DESCRIPTION	SHT. NO.
GENERAL LAYOUT	93
GENERAL NOTES	94-95
42" WATER MAIN PLAN AND PROFILE	96-100
24" WATER CONNECTION PLAN AND PROFILE	101
12" WATER CONNECTION PLAN AND PROFILE	102-103
CORROSION PROTECTION	104-109
WATER DETAILS	110-113

STATE OF HAWAII DEPARTMENT OF TRANSPORTATION HIGHWAYS DIVISION	
GENERAL LAYOUT	
KAHEKILI HIGHWAY WIDENING Likeli Hwy. to Vicinity of Haiku Road F.A. PROJECT NO. NH-083-1(26)	
SCALE: AS NOTED	DATE: APRIL 1994
SHEET No. WT1 OF WT21 SHEETS

STATE OF HAWAII DEPARTMENT OF TRANSPORTATION HIGHWAYS DIVISION	
GENERAL WATER NOTES	
KAHEKILI HIGHWAY WIDENING Likelike Hwy. to Vicinity of Haiku Road F.A. PROJECT NO. NH-083-1(26)	
SCALE: AS NOTED	DATE: APRIL 1994
SHEET No. WT2 OF WT21 SHEETS

PLAN AND PROFILE
42" WATER MAIN
W.L. STA. (-)1+85.97 TO 9+50

PLAN AND PROFILE
KAHUHIPA STREET
12" W.L. CONN. TO 42" WATER MAIN

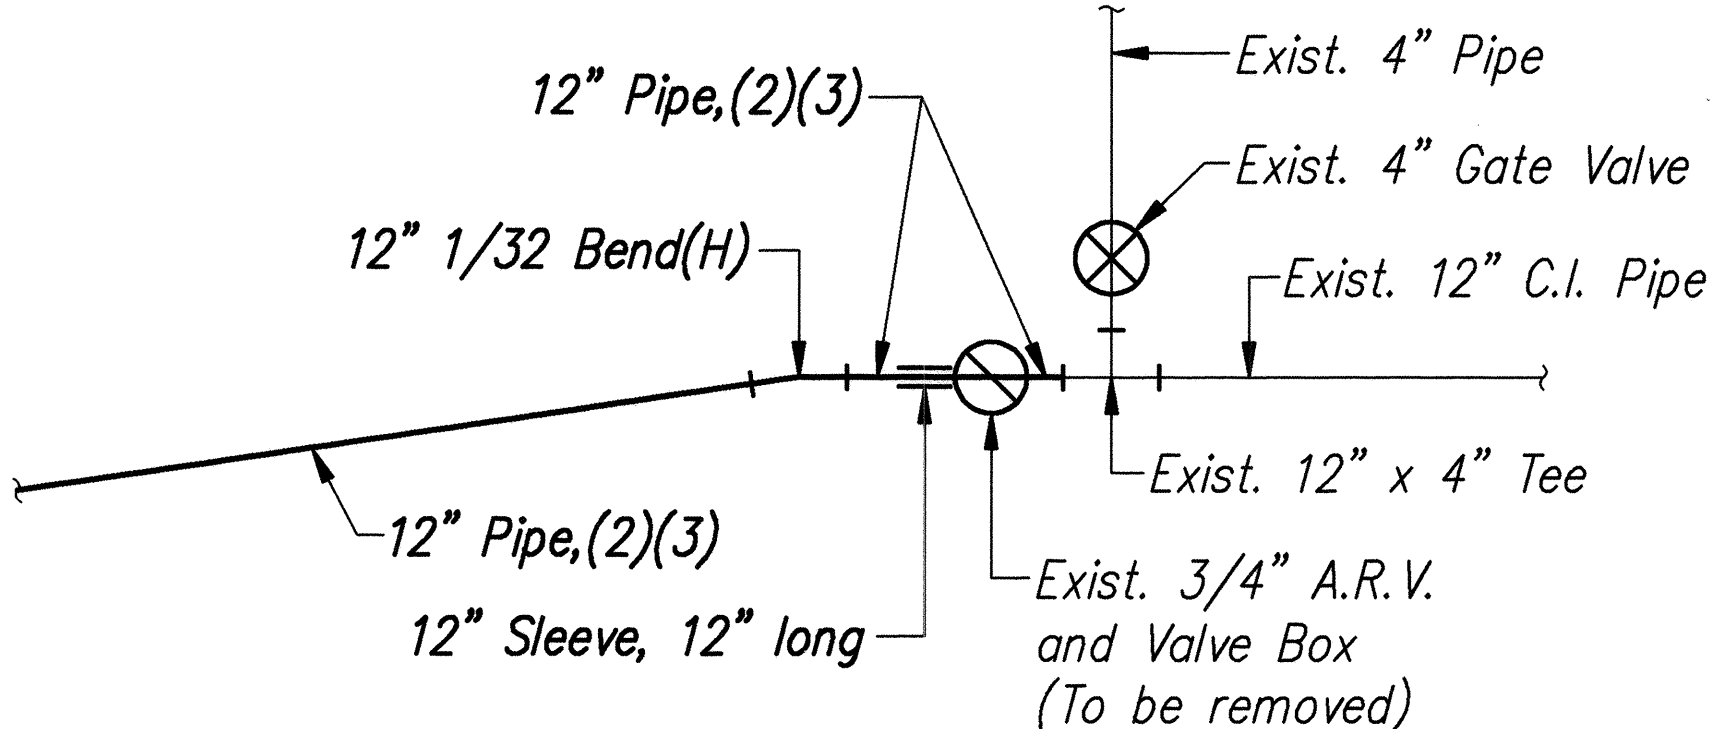
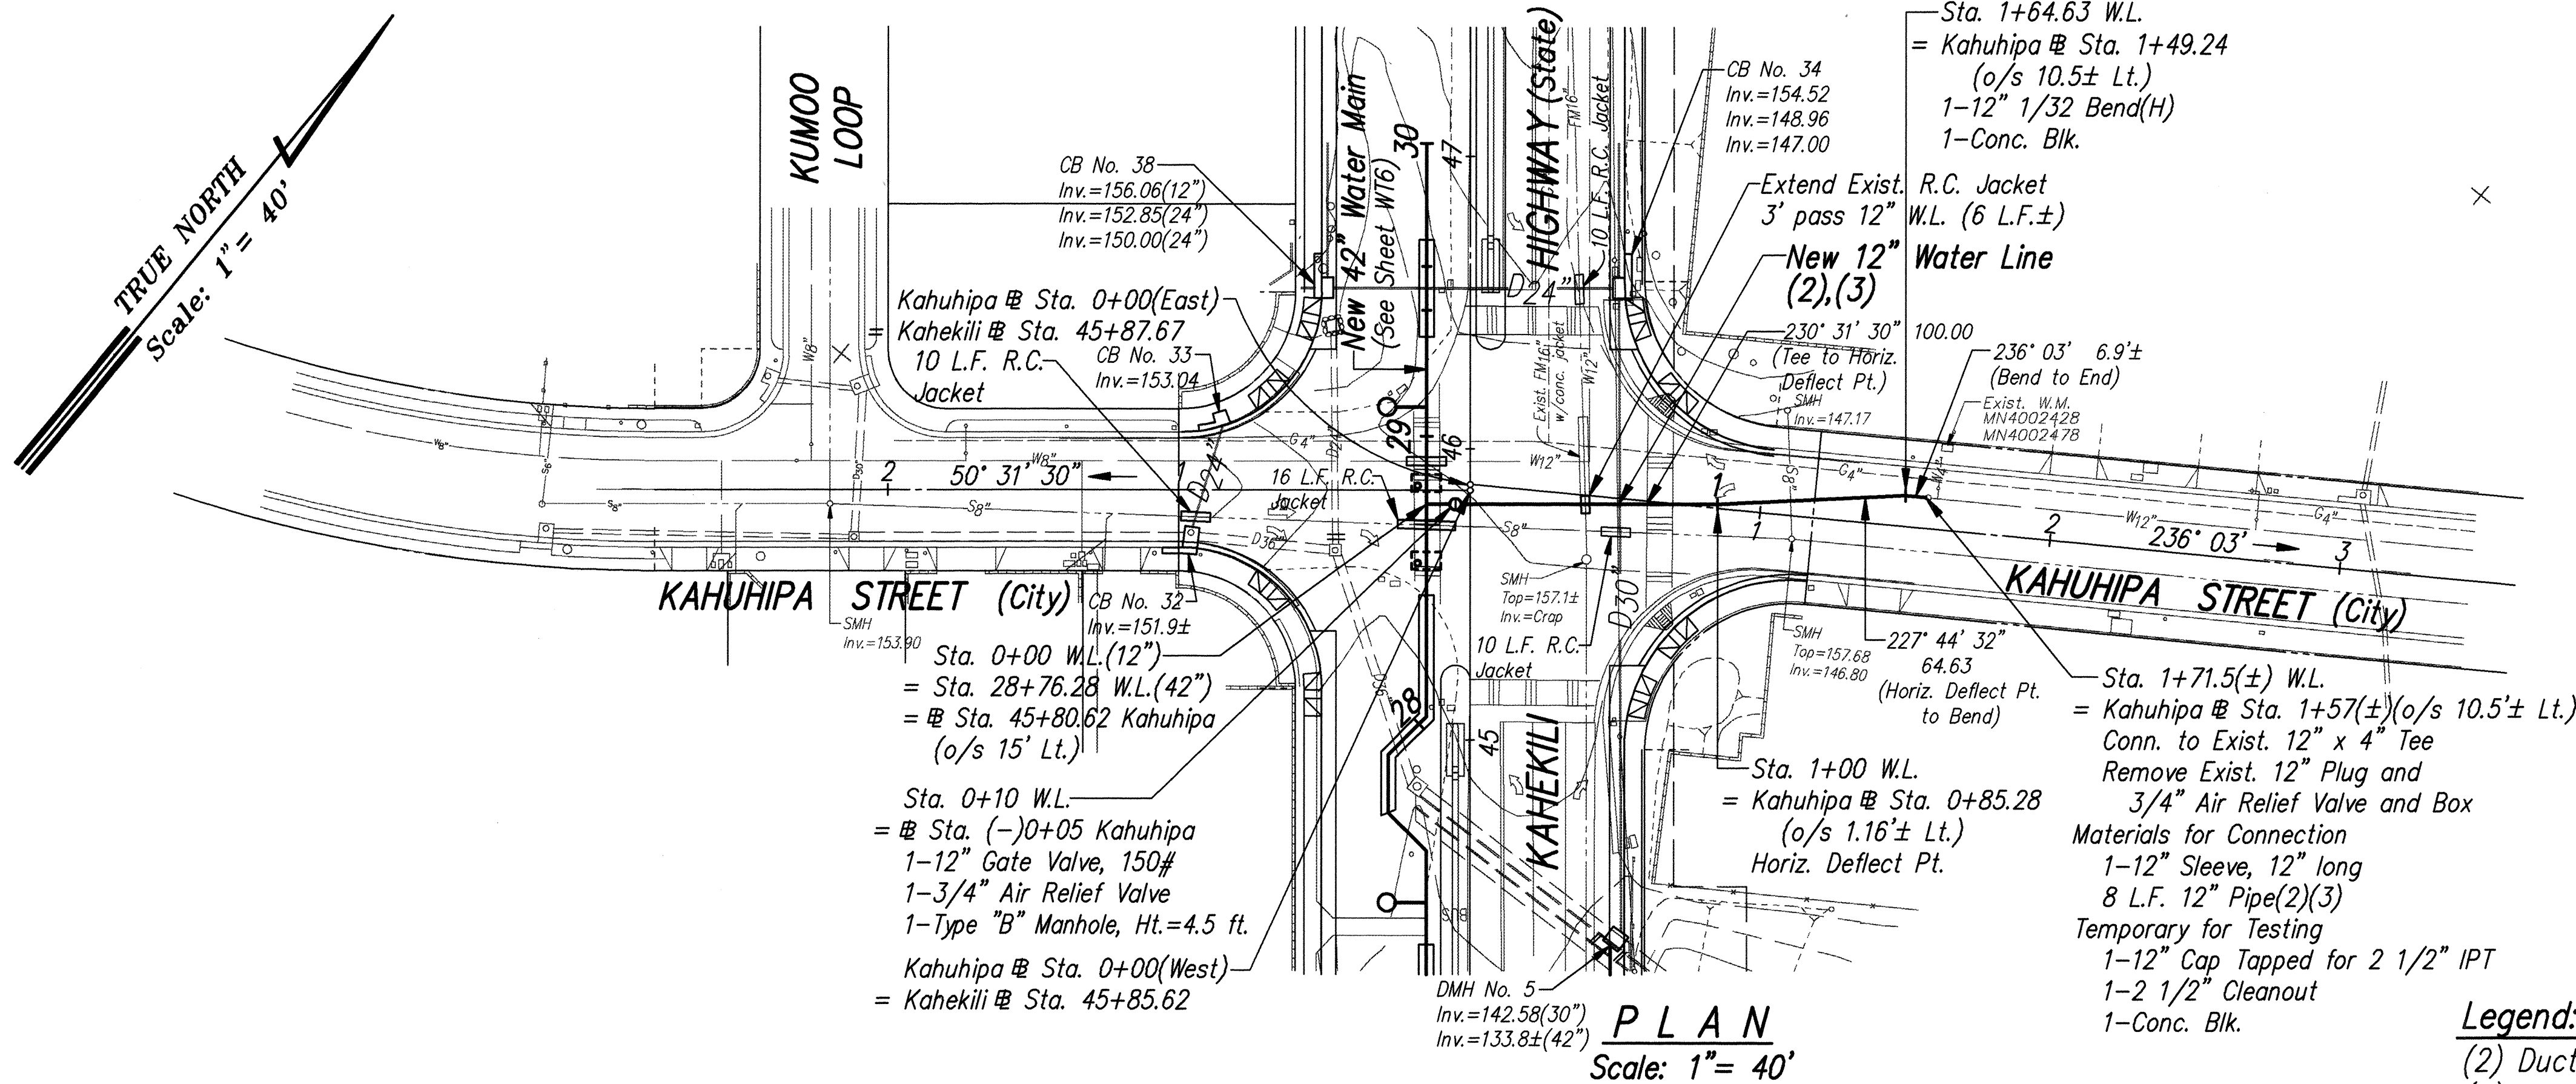
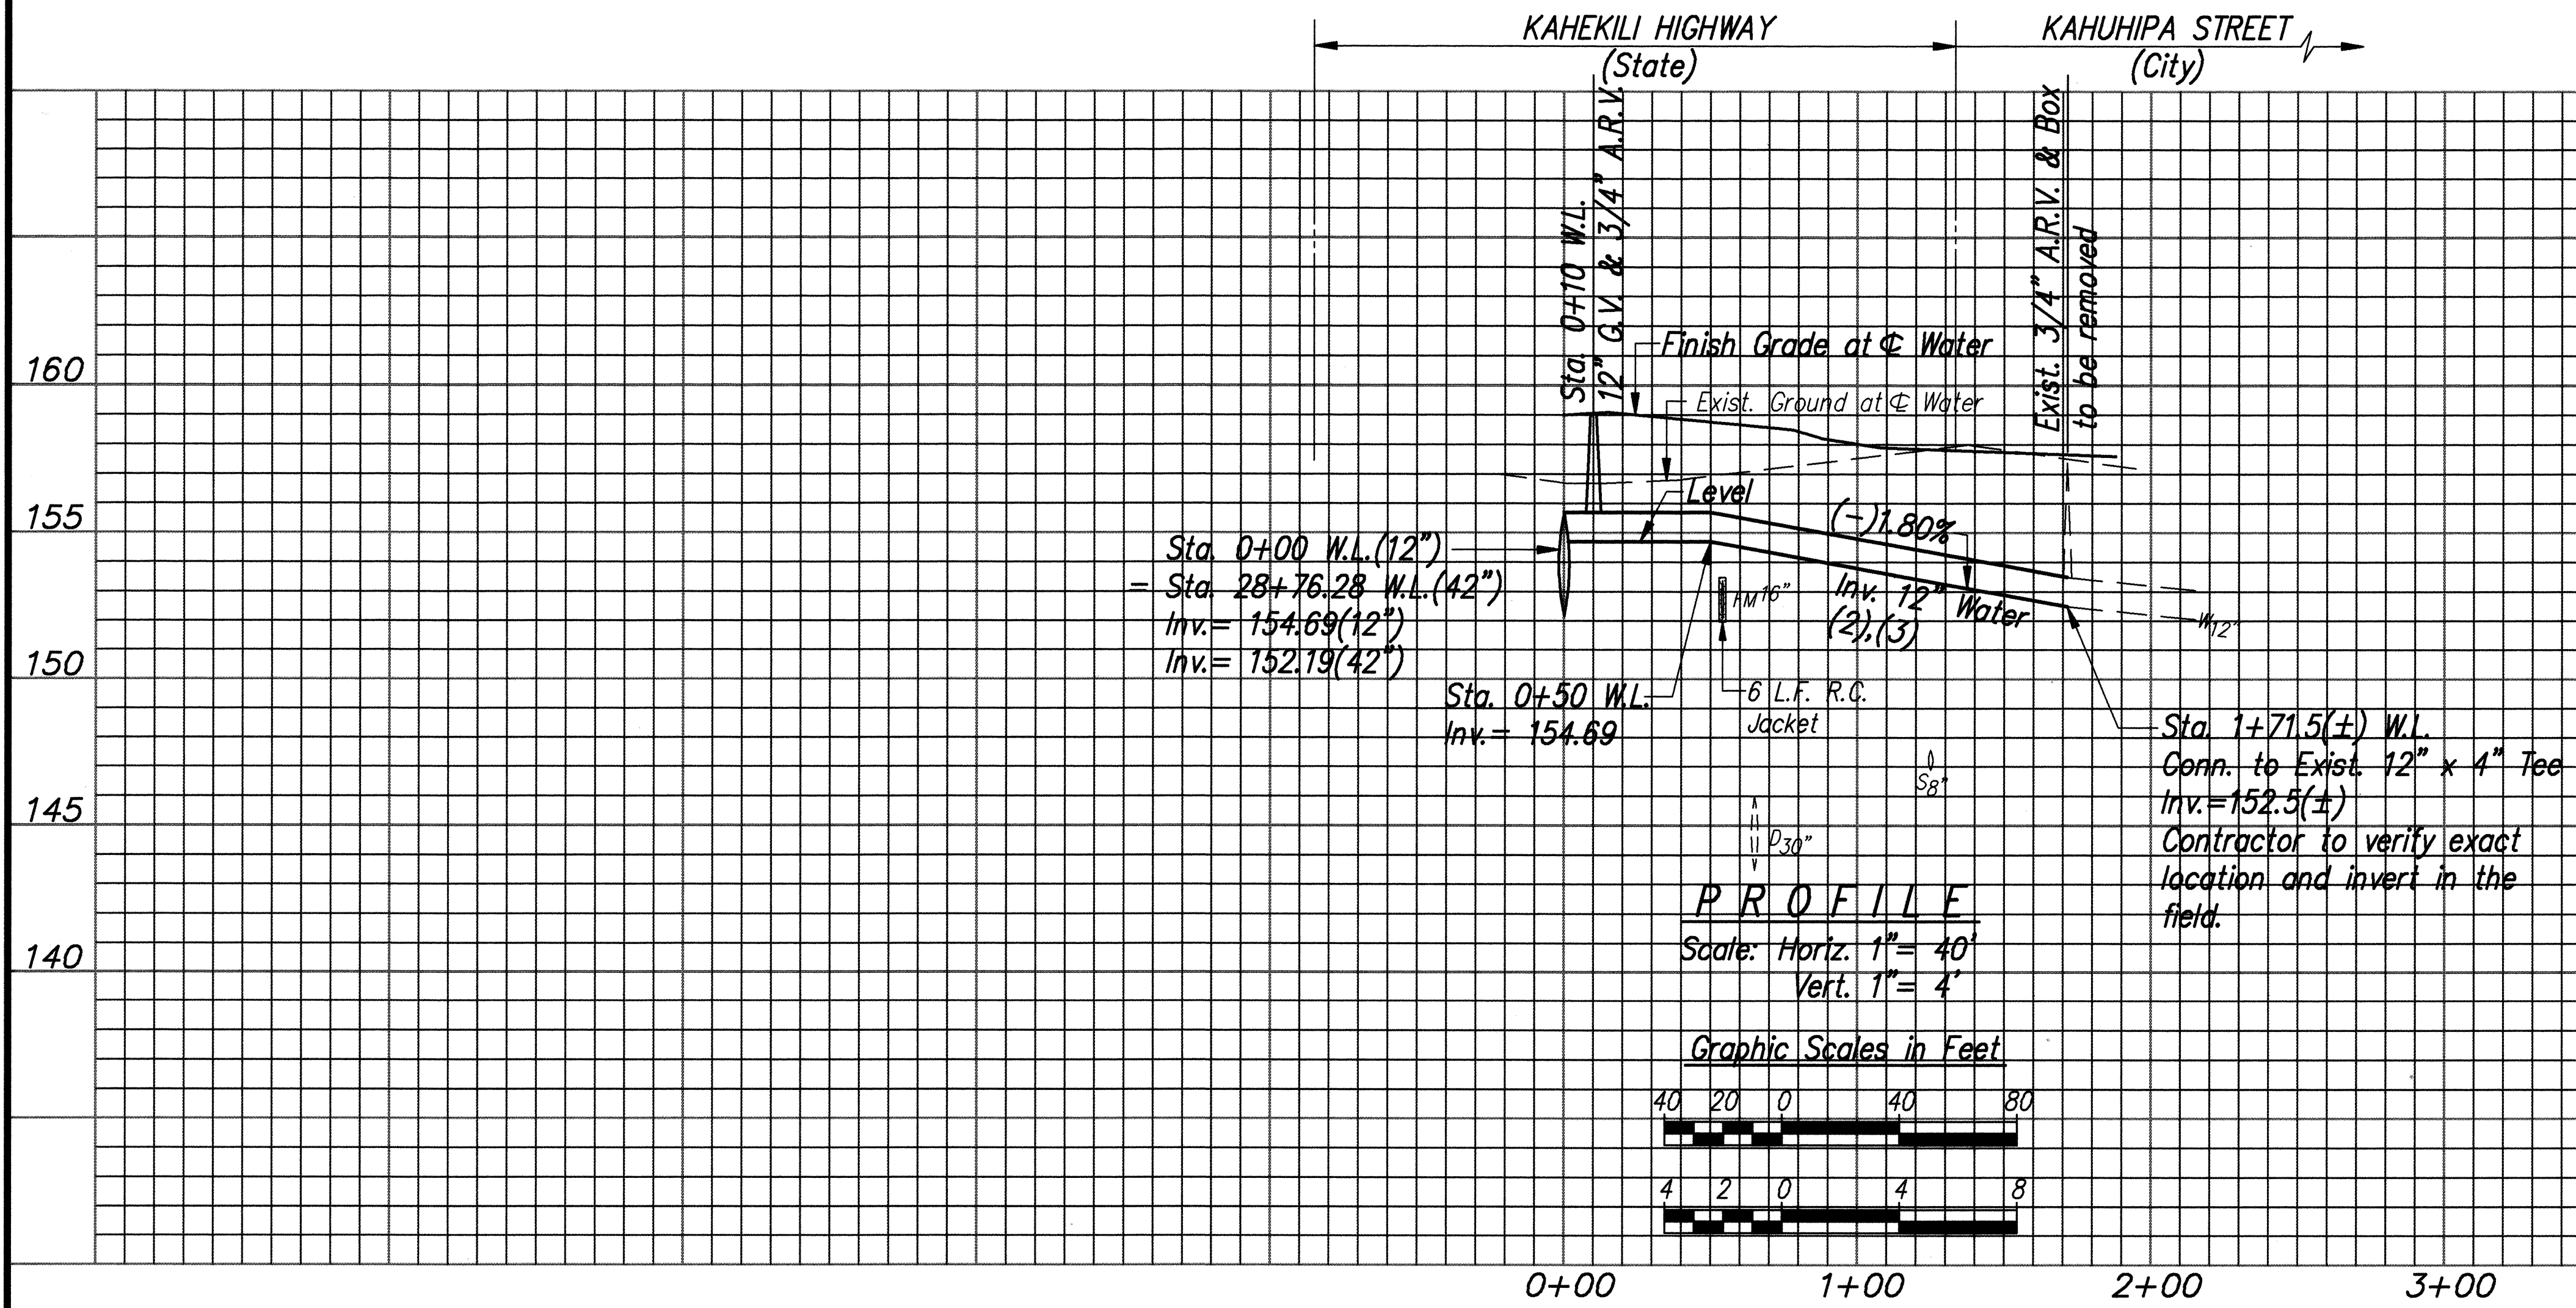
7/13/94	REVISED LOCATION OF 42" B.F. VALVES AND MANHOLES. ADDED R.C. JACKET
DATE	REVISION

**KAHEKILI HIGHWAY
42" WATER MAIN**

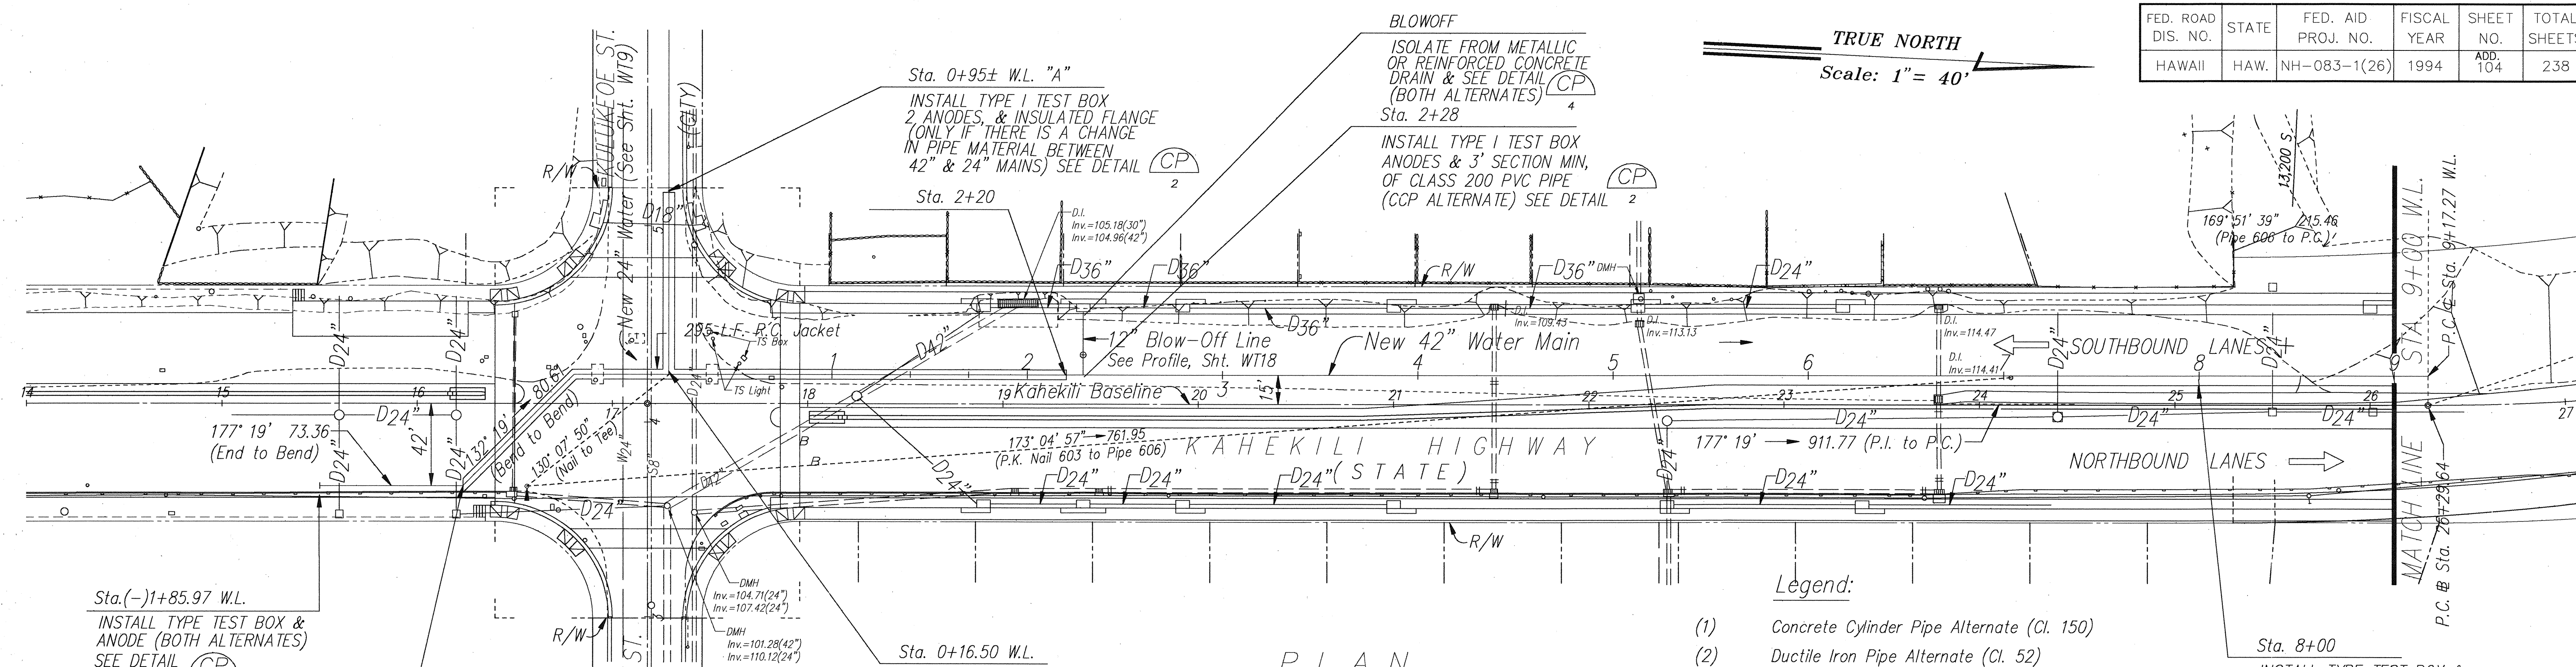
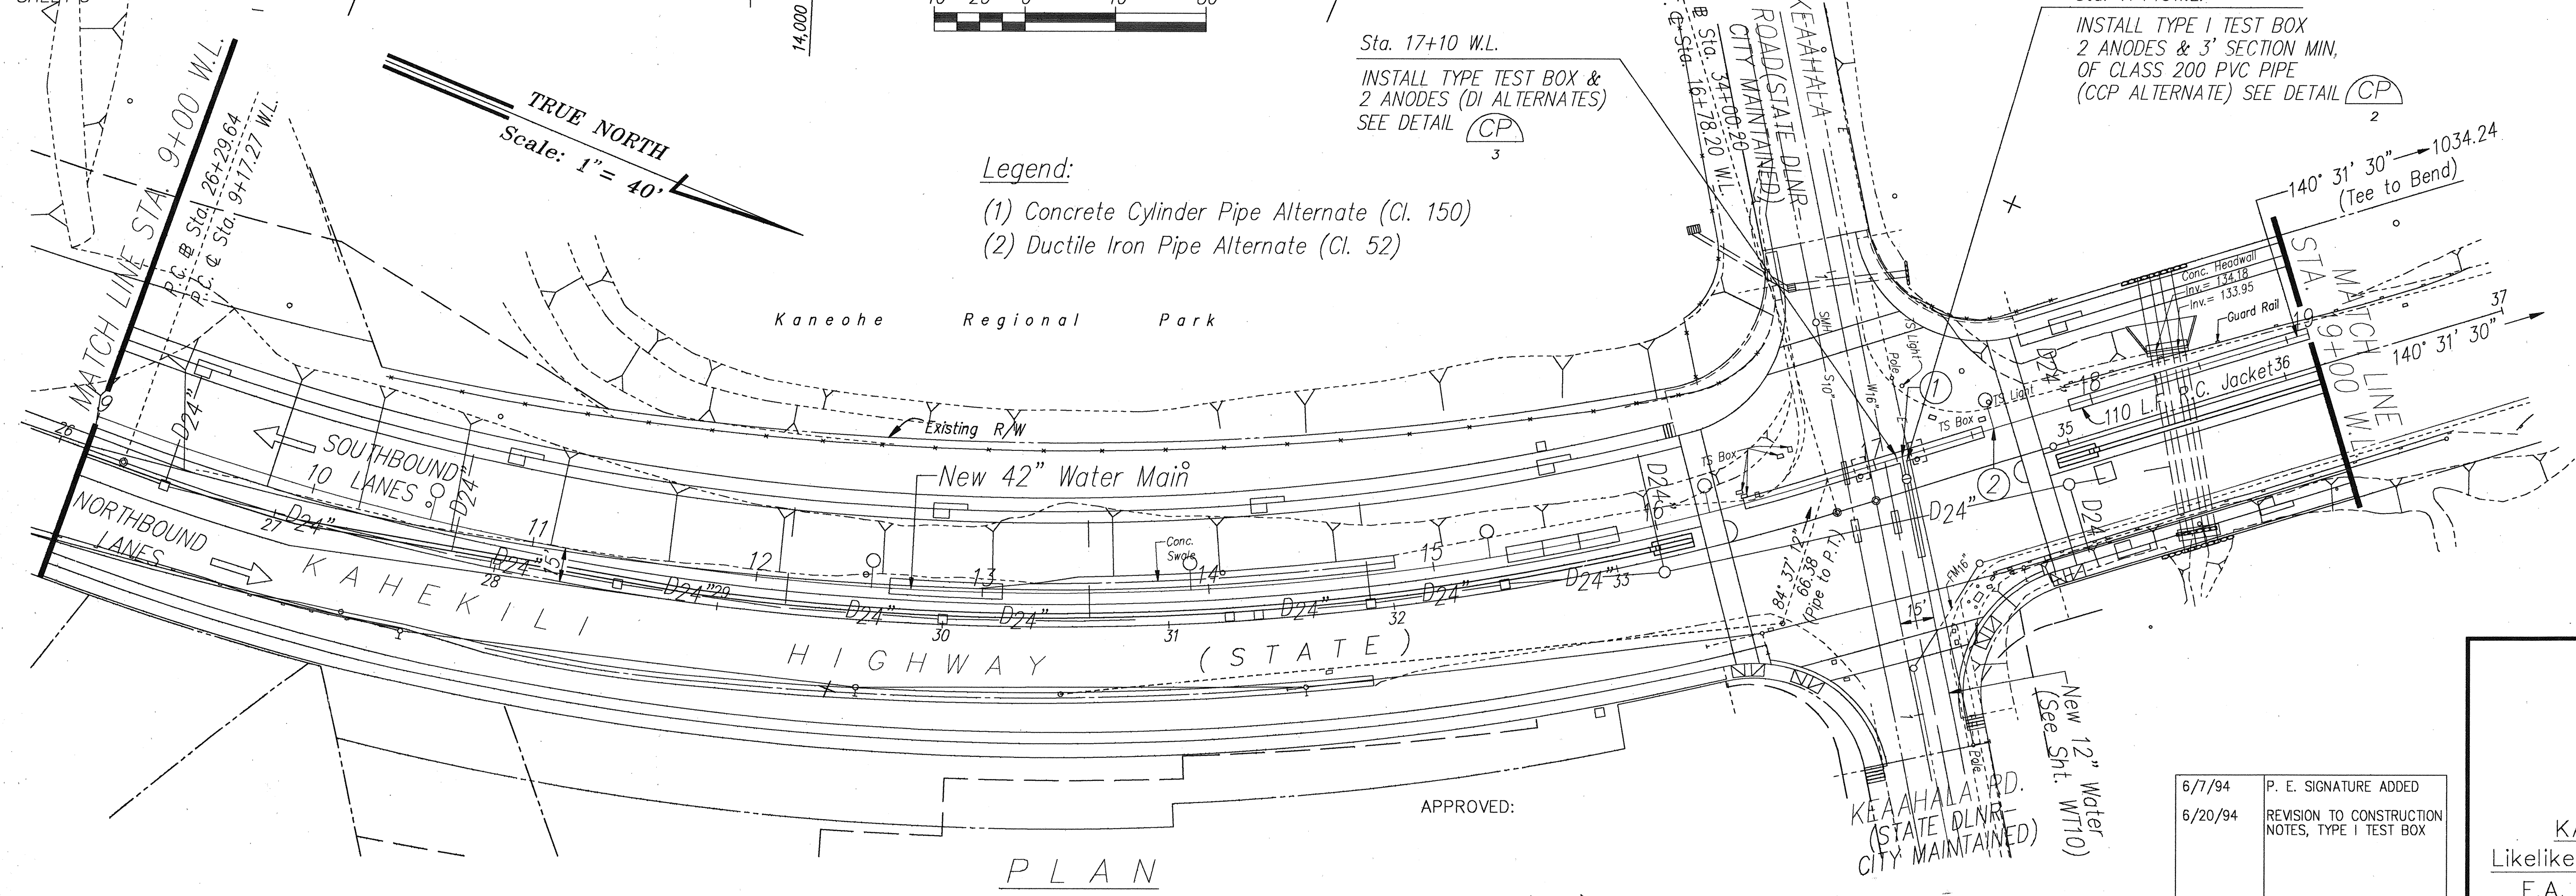
DATE	REVISION
6/7/94	P. E. SIGNATURE ADDED
6/20/94	REVISION TO CONSTRUCTION NOTES, TYPE I TEST BOX
